VILLAGE OF LOMBARD
REQUEST FOR BOARD OF TRUSTEES ACTION
For Inclusion on Board Agenda

TITLE: PC 17-03, 543 E. Taylor Road (Park District Recreation Center)

SUBJECT: **PC 17-03, 543 E. Taylor Road (Park District Recreation Center)**

February 6, 2017

LANDSCAPE PLAN
WILSON ROAD

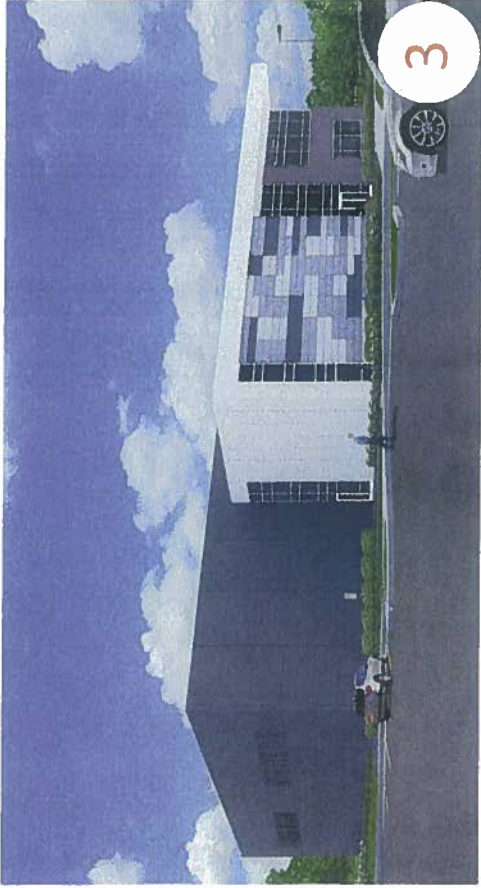
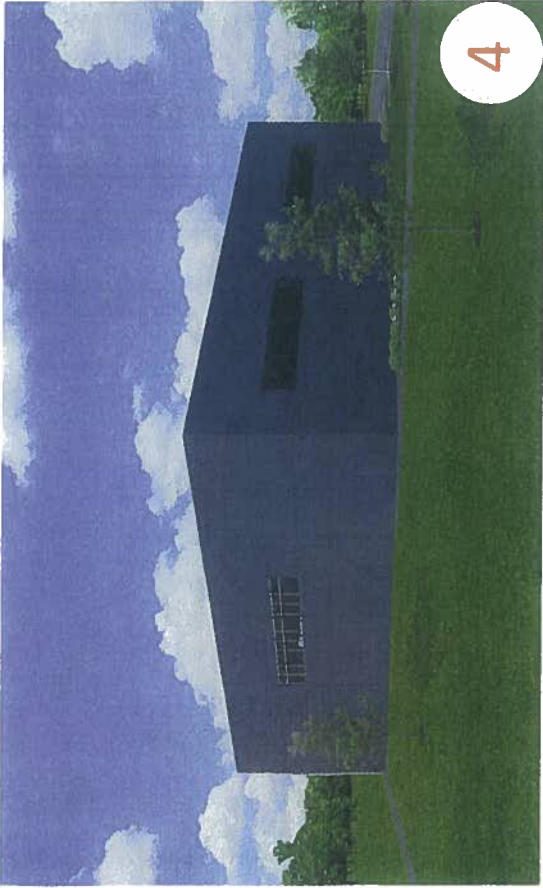
- The landscape plan provided by the petitioner lacks foundation landscaping along the north and northeast side of the building, which can be included in an updated plan at time of permitting. Otherwise, the landscape plan meets the requirements in the Zoning Ordinance.

- d. Landscape plans, prepared by FGM Architects, dated December 9, 2016, to be amended to address foundation landscaping as noted in this report; and
